PTS STANDARDS - 100 SERIES DRAWINGS
STANDARDS FOR ROADWAY CONSTRUCTION
APRIL 2022 EDITION – CHANGE NO. 2 – NOVEMBER 2023

PTS – 100 SERIES DRAWINGS

PENNSYLVANIA TURNPIKE COMMISSION
INDEX OF STANDARDS FOR ROADWAY CONSTRUCTION

FILE NAME: PTS-140-3.dwg
DRAWING TYPE: 5A
SHEET 3 OF 3

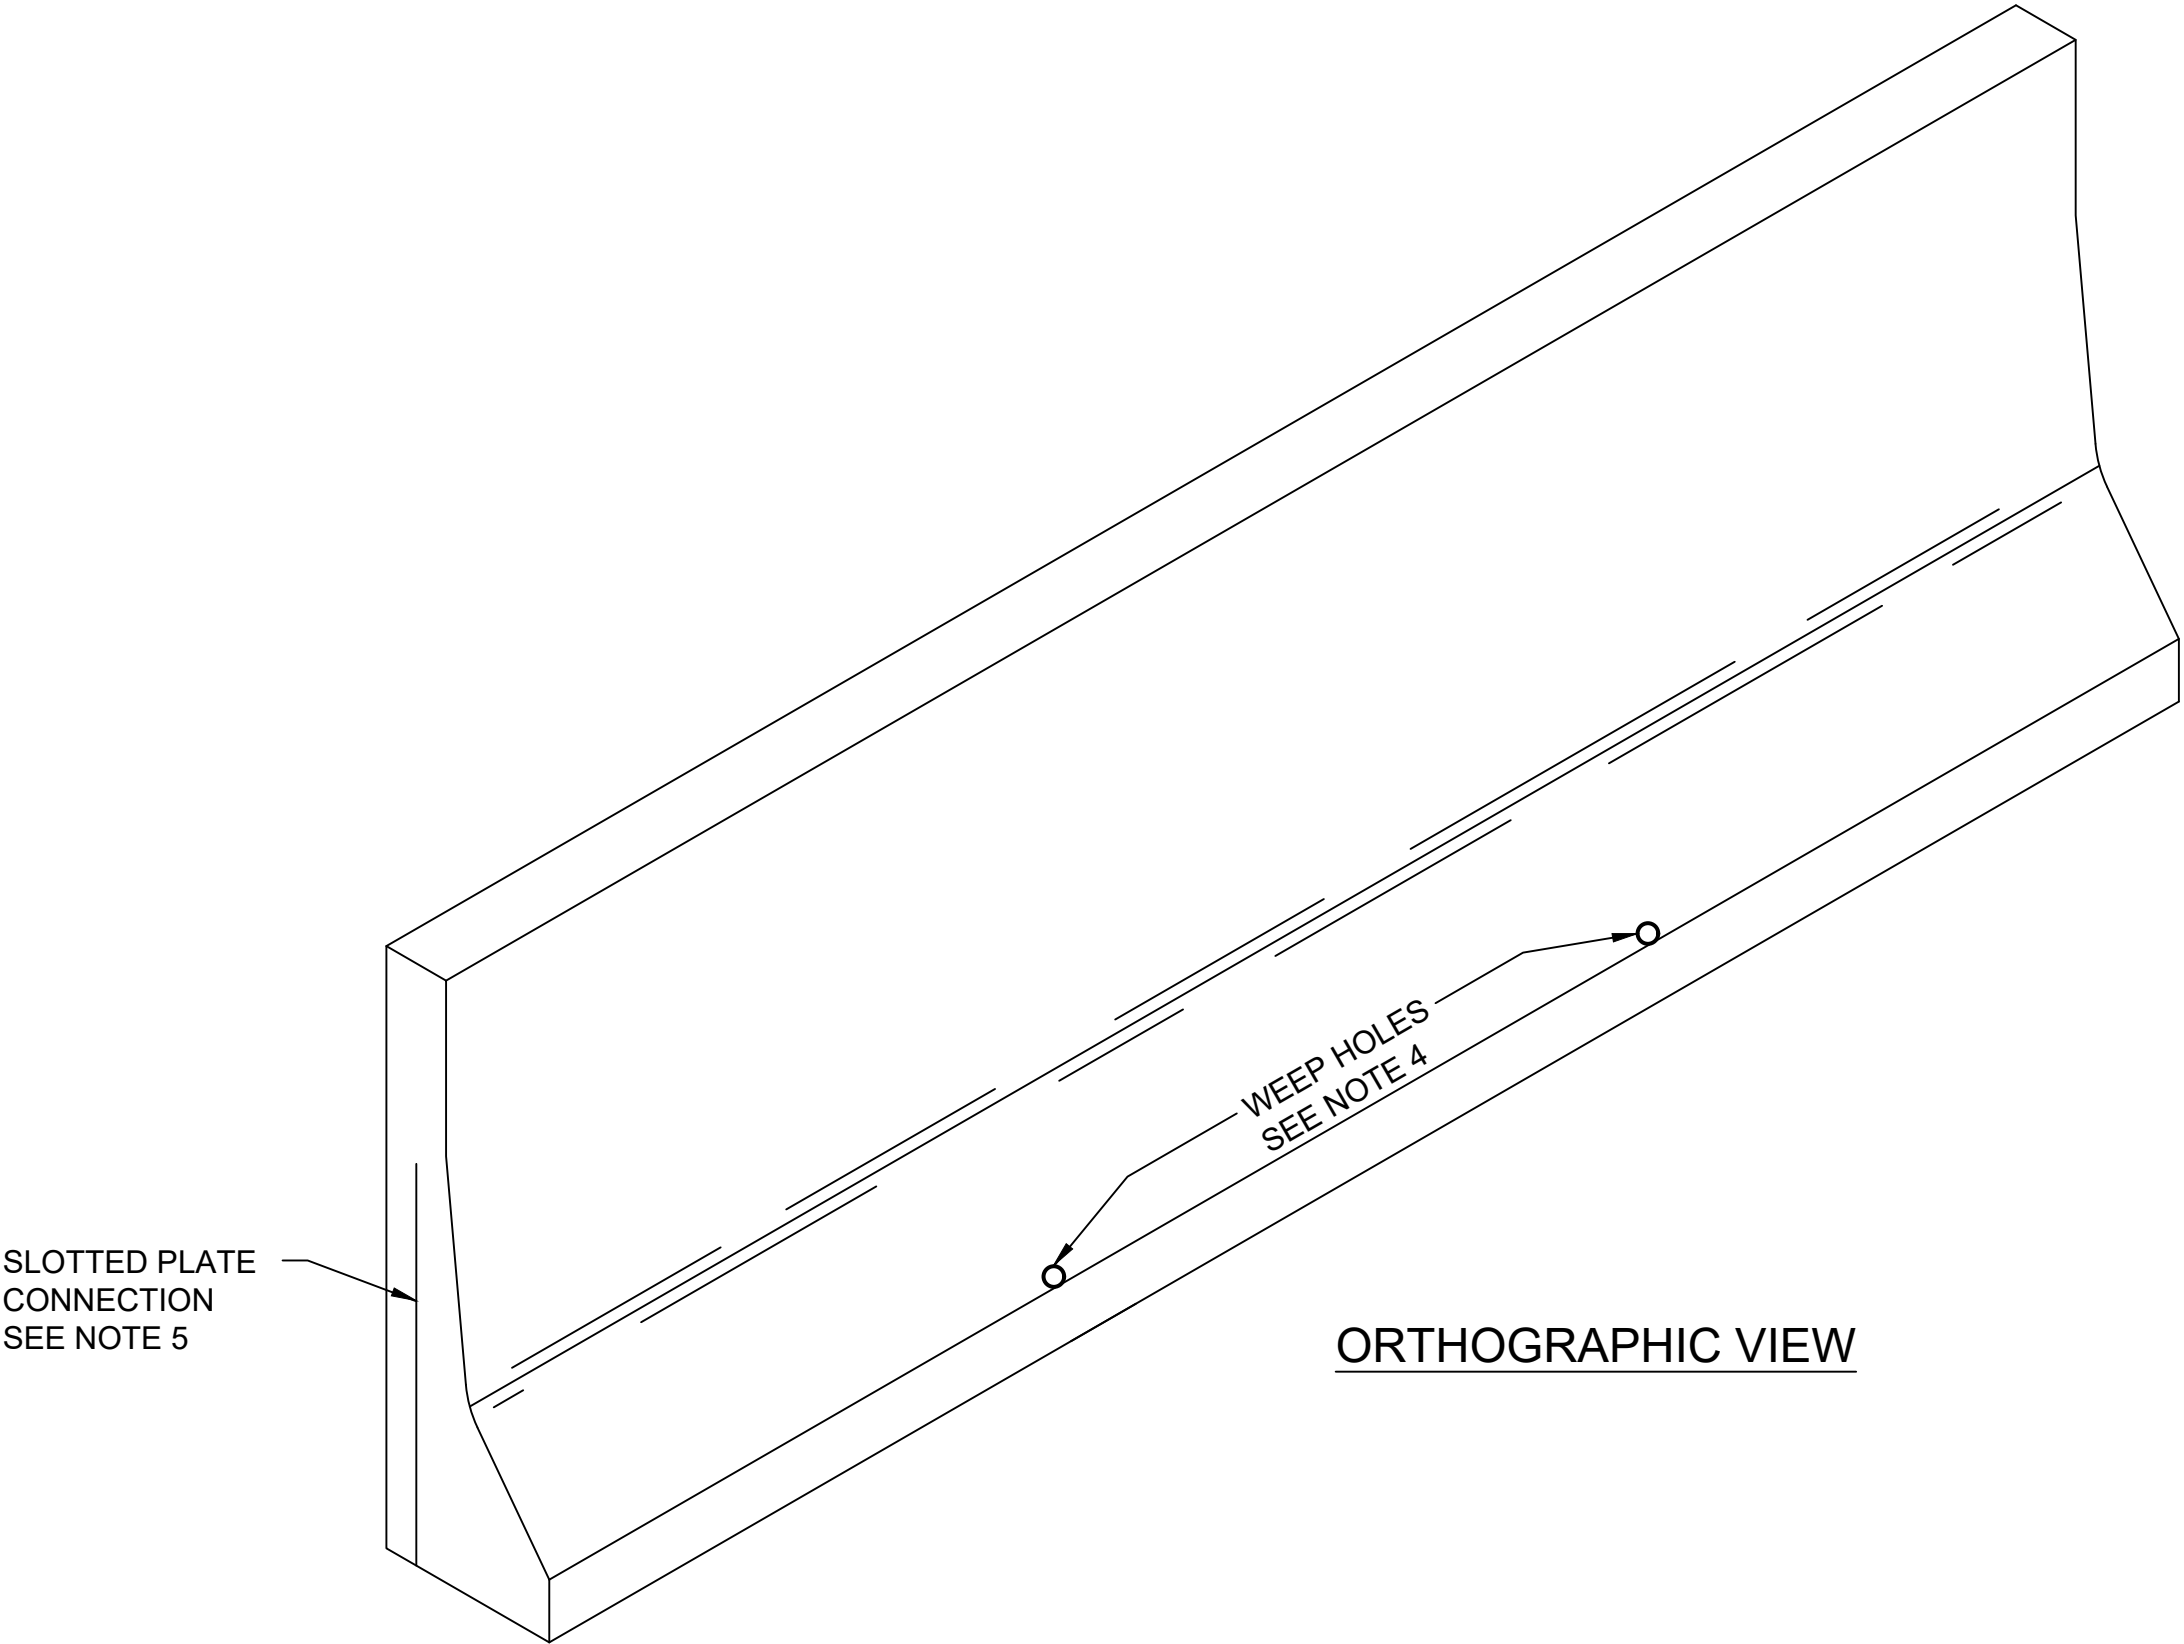
REVISED TRANSITION PIECE LENGTH FROM VARIABLE TO 12’.
REORGANIZED SECTION AND PROFILE VIEWS TO ALIGN HORIZONTALLY.
ADDED TEXT CALLOUT TO THE PROFILE VIEW - 2" ELEVATION CHANGE / STEP BETWEEN PIECES AND
“SAWCUT THROUGH PAVEMENT TO ALLOW STEEL PLATE CONNECTION BETWEEN SECTIONS”.
ADDED NOTES 10 AND 11.

FILE NAME: PTS-144-1.dwg	SHEET 1 OF 1
DRAWING TYPE: 5A	
DATE: NOVEMBER 2023	PTS-144

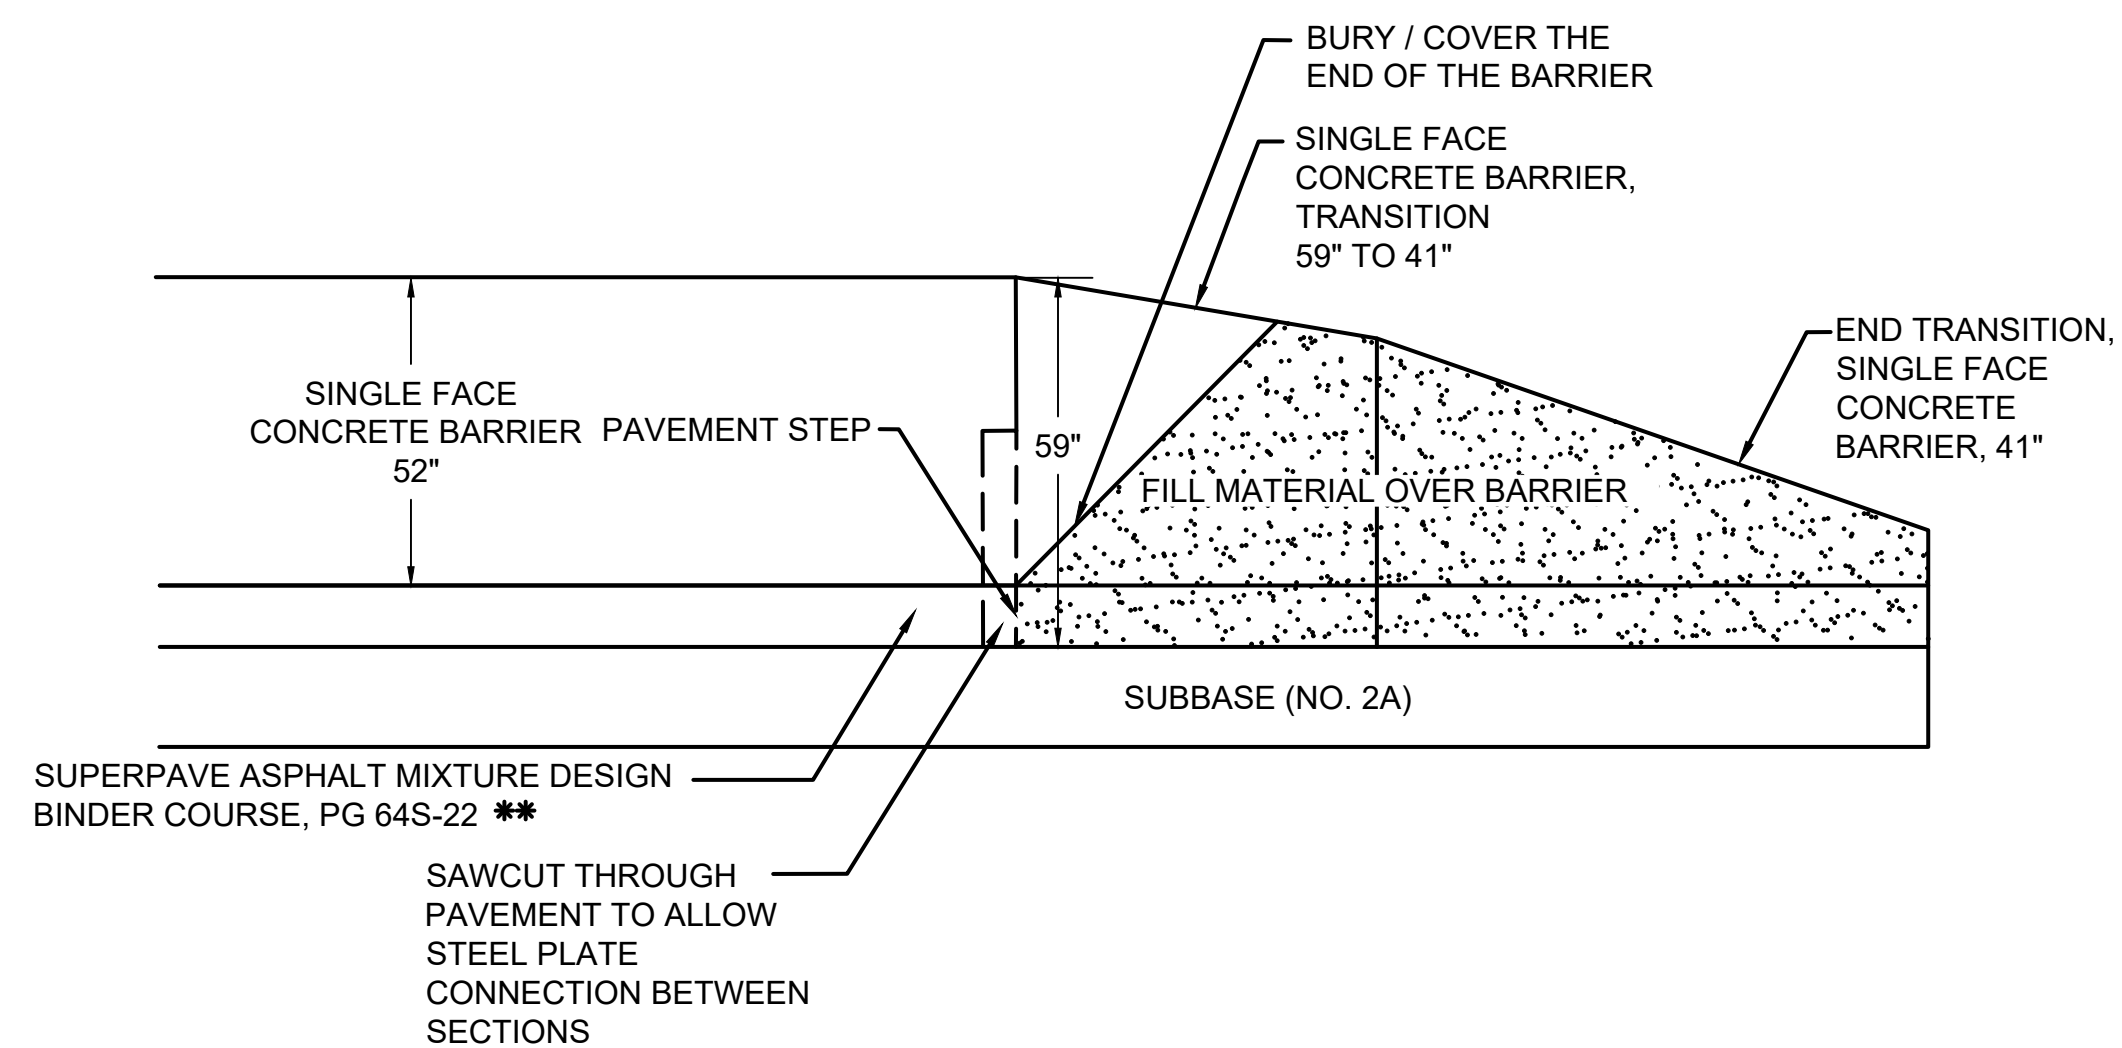
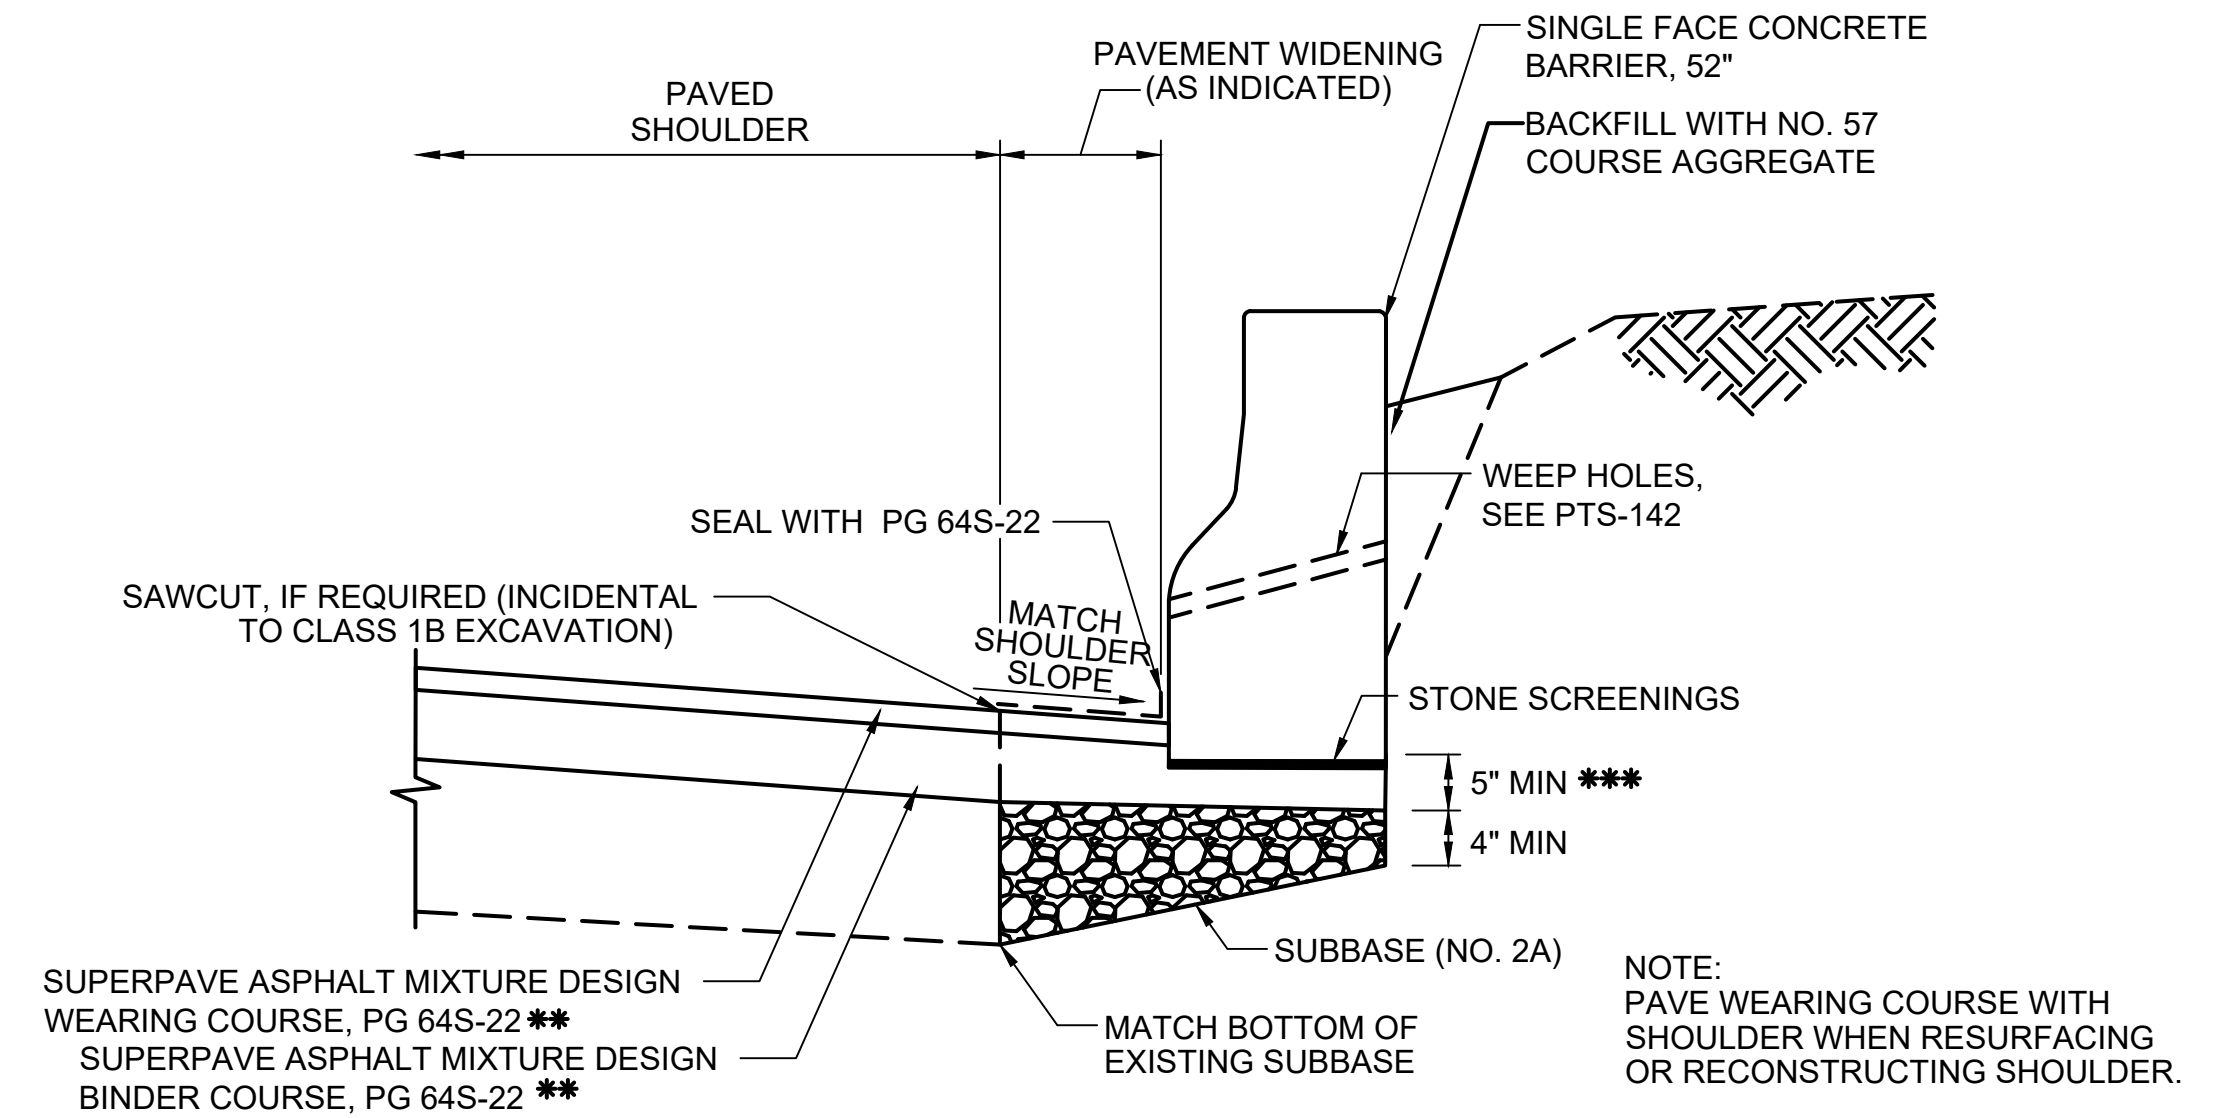
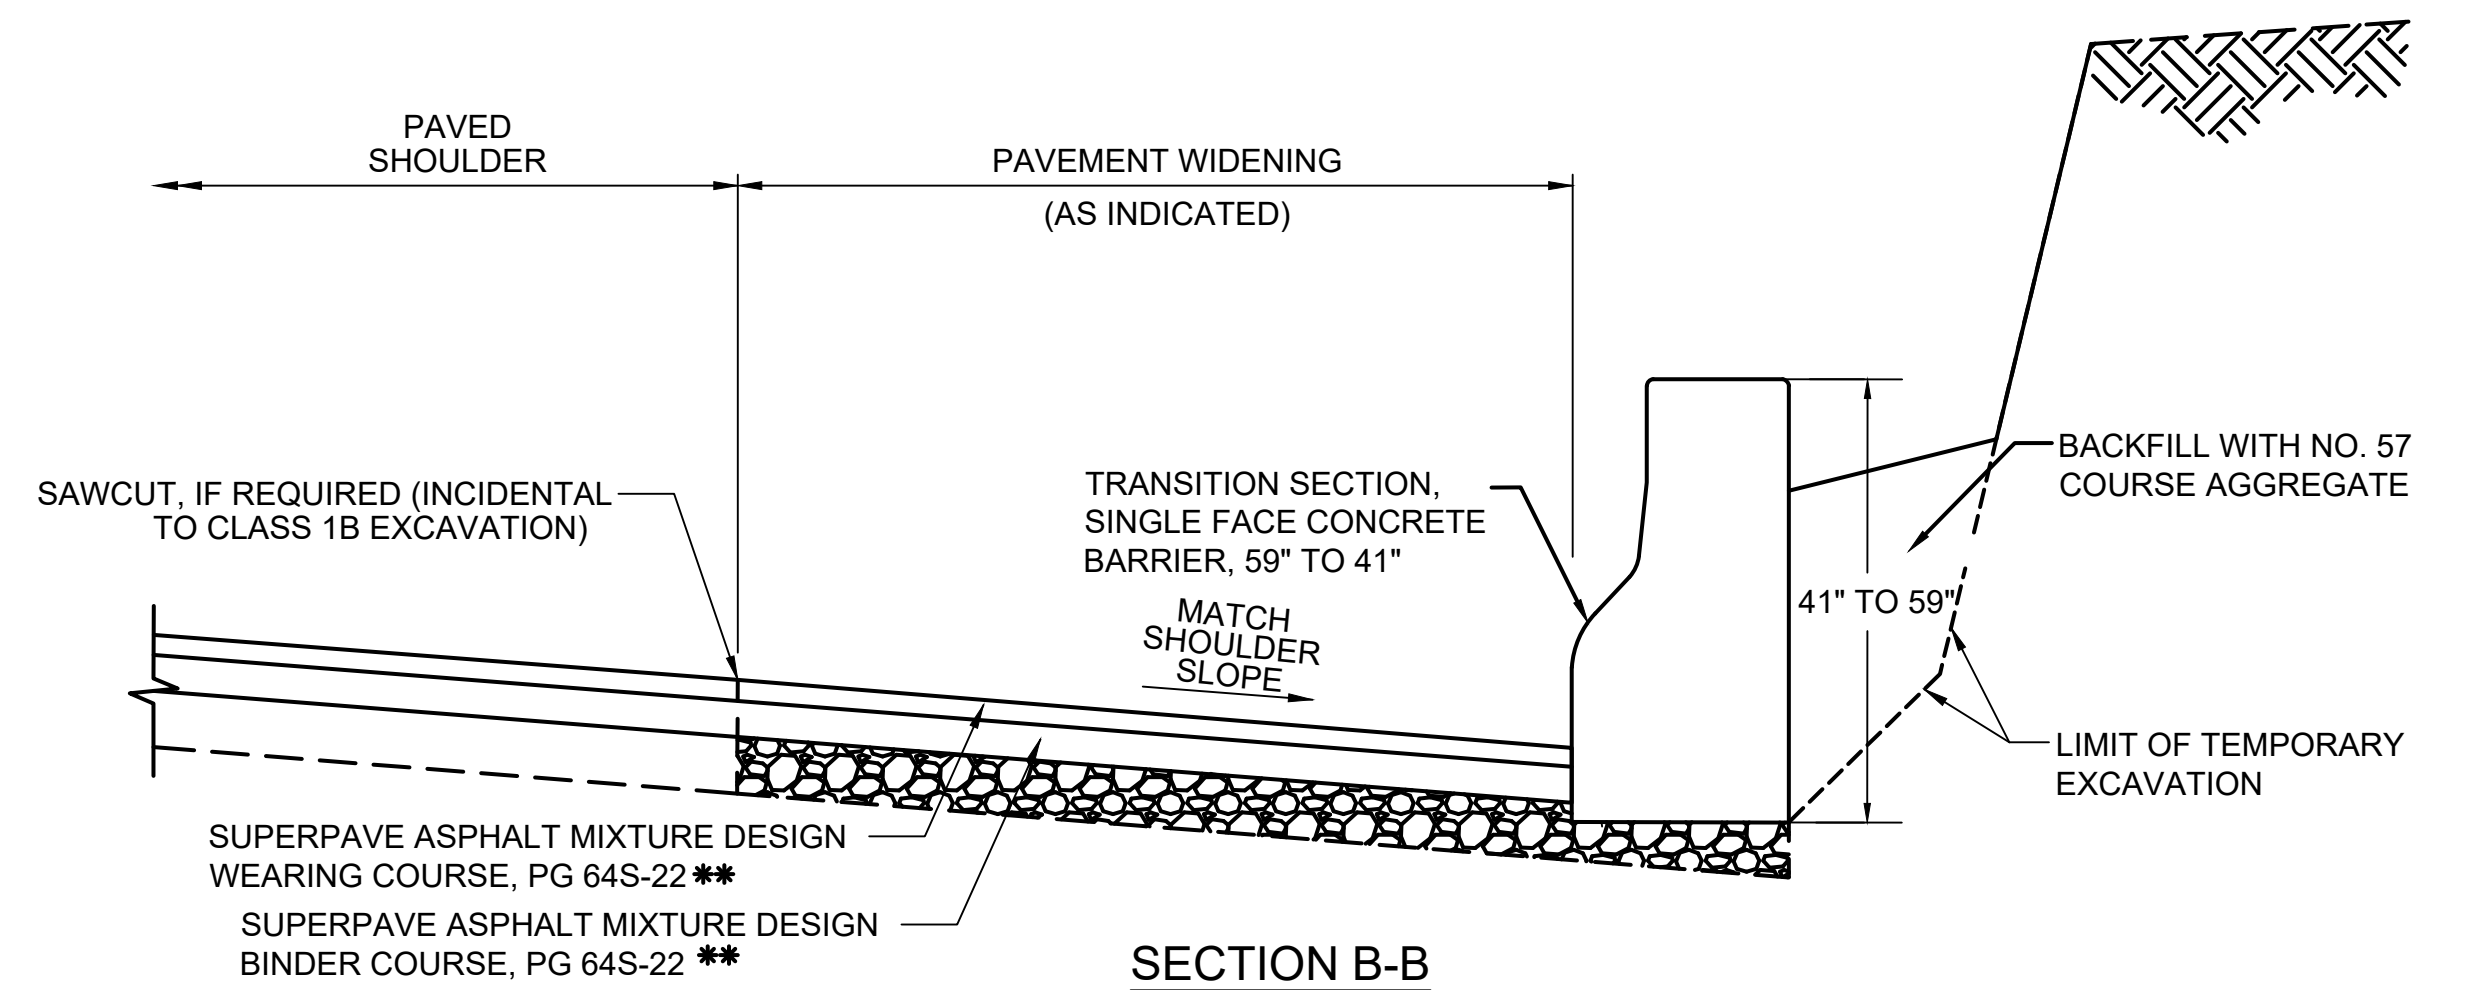
ADDED A PROFILE VIEW.
REVISED THE PLAN VIEW TO INDICATE THE REFERENCE SECTION LOCATIONS.
ALIGNED SECTION VIEWS VERTICALLY AND ADDED A PATTERN TO THE SUBBASE LAYER.
